Inland Rail – Narrabri to North Star EIS - SS1 7474

Annexure A – Review of Technical Report 1 Traffic, Transport and Access Assessment

Annexure B – Prior advice to GHD 28/6/16

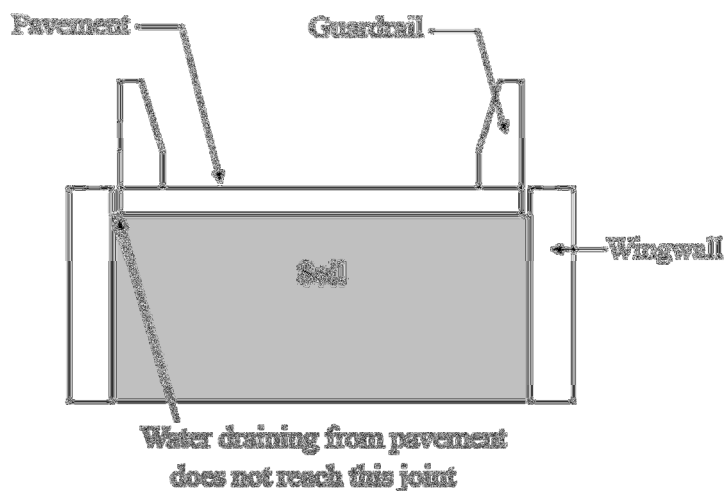
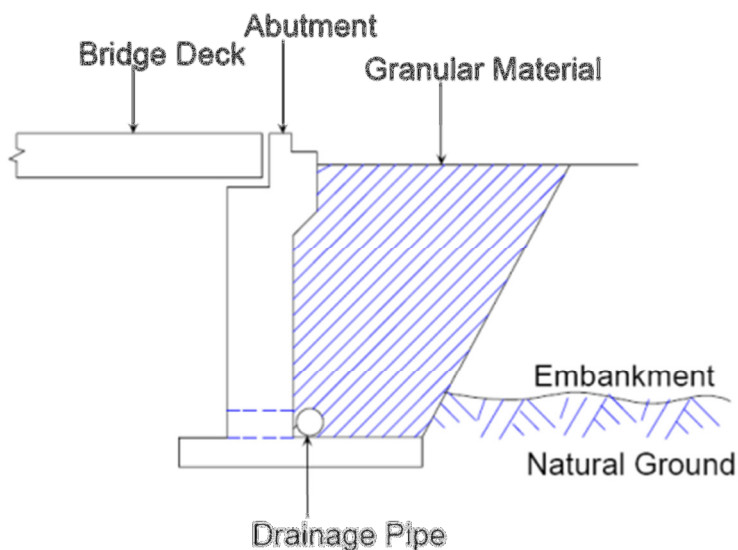
- RMS/ARTC responsibilities at existing bridge Newell Highway road over rail bridge, approximately 3kms north of Bellata

RMS maintains the road pavement on approaches and the wearing surface across the bridge deck, as well as the guard rail traffic barriers on the approaches to the bridge. The rail authority maintains the bridge structure itself (including piers, abutments, spans, deck concrete and bridge traffic barriers).

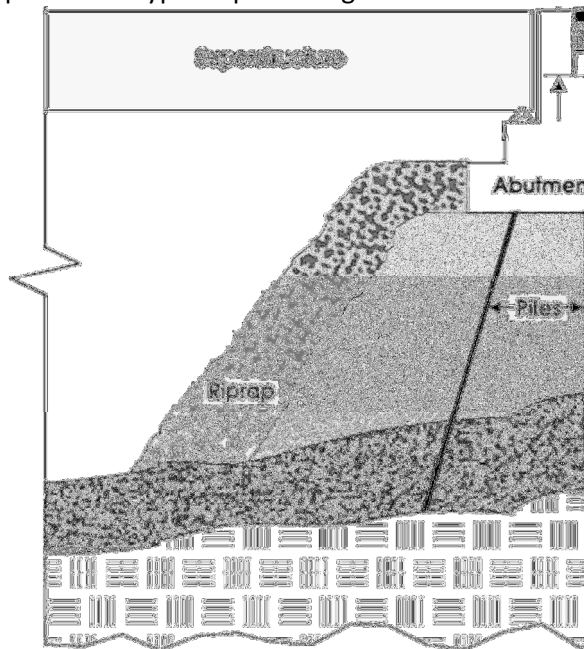
- Below is a typical boxed abutment and, for comparison, a spill through abutment. Note: RMS no longer uses spill through abutments:

As opposed to a typical spill through abutment below:

With regard to spill through abutments, a typical spill through abutment is covered with rock riprap (as shown above). In expansive soils (such as soils around Narrabri) the abutment fill beneath the riprap tends to settle / move over time. This movement causes the rip rap layer to settle, which exposes the abutment to erosion (particularly erosion under abutment headstocks). Erosion of the abutment leads to pavement failure on approach to the bridge.
